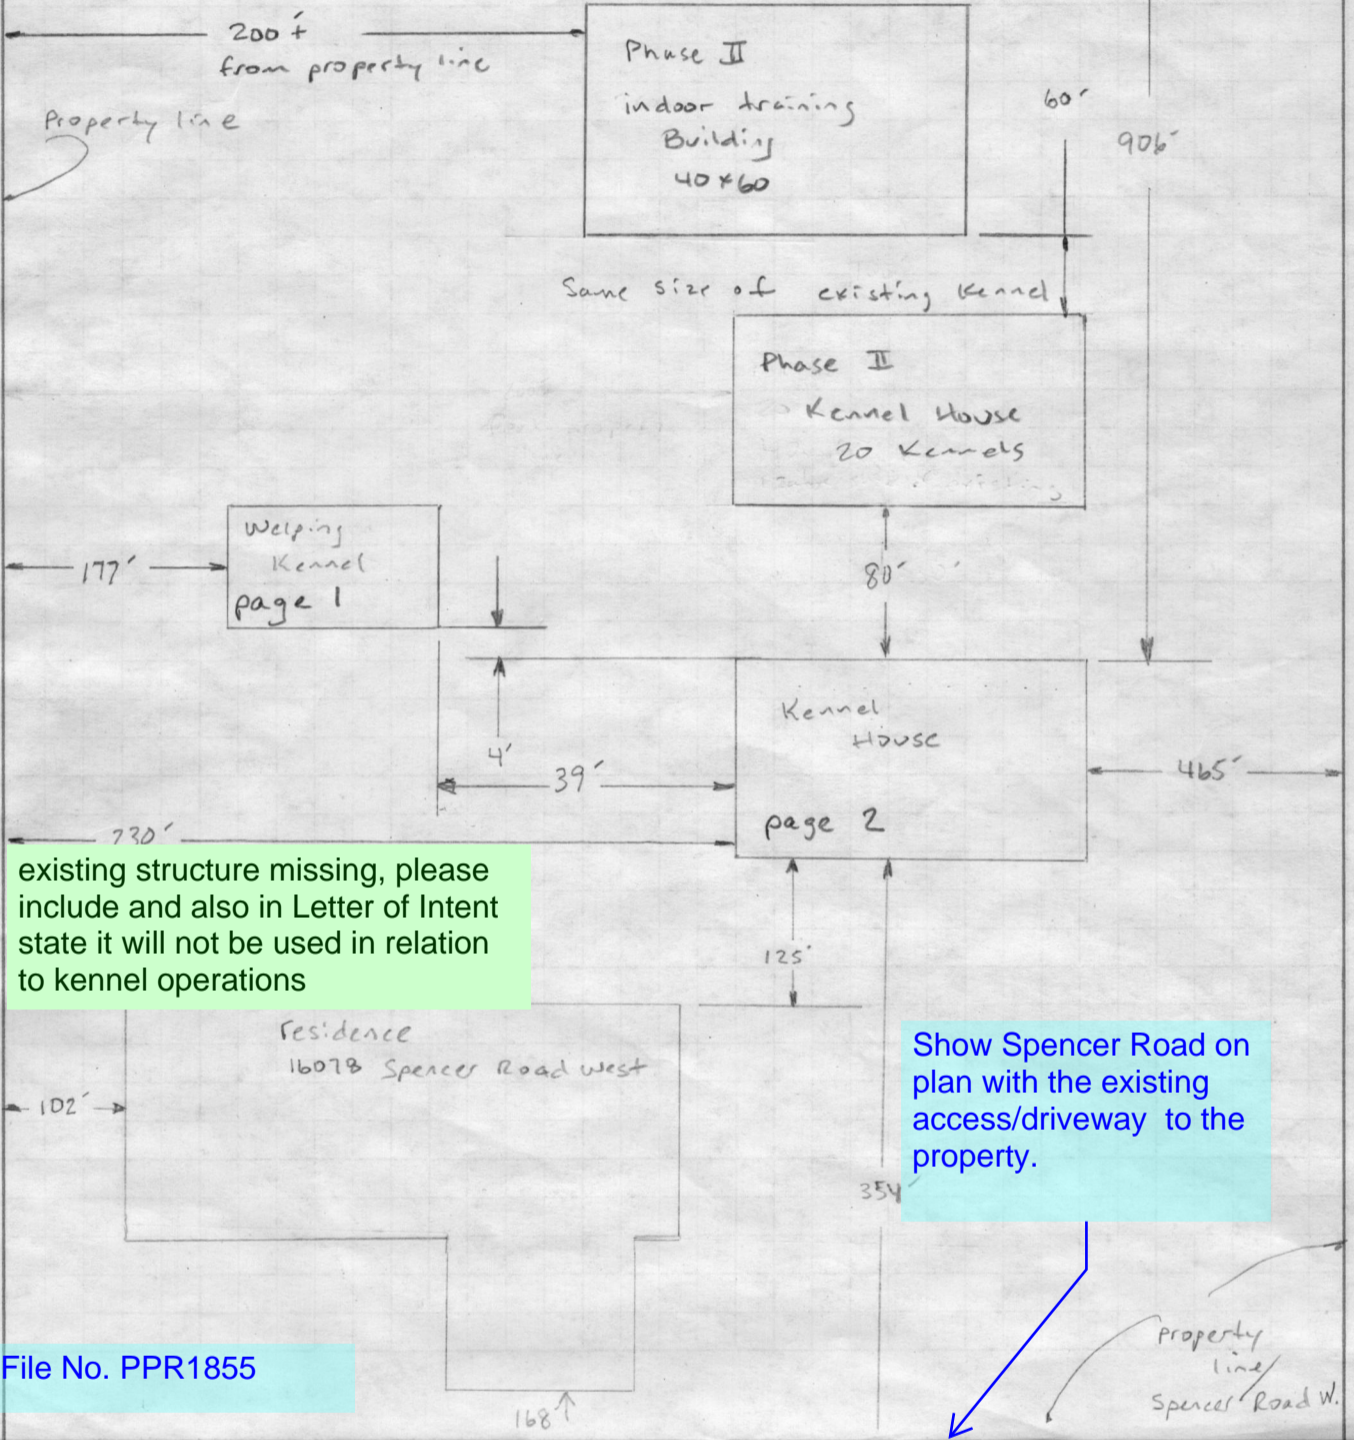
Show and label all existing structures on plan with dimensions to property lines. The letter of intent indicates that there are 4 outbuildings and 1 shed. Only 2 existing outbuildings are shown.

existing structure missing, please include and also in Letter of Intent state it will not be used in relation to kennel operations

Show Spencer Road on plan with the existing access/driveway to the property.

Add PCD File No. PPR1855

Landscape plans

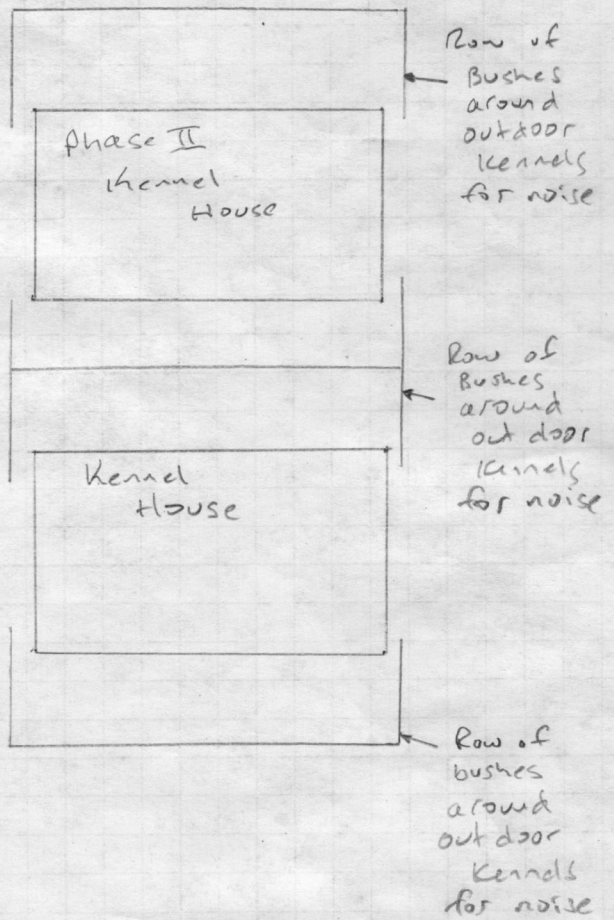
Not a Landscape plan. This needs to have a legend of what the plant or tree is, the required amount, then the provided amount. If you cannot meet the minimum of Chapter 6 of the Land Development Code, you must request an 'Alternative Landscape Design' in your letter of intent.
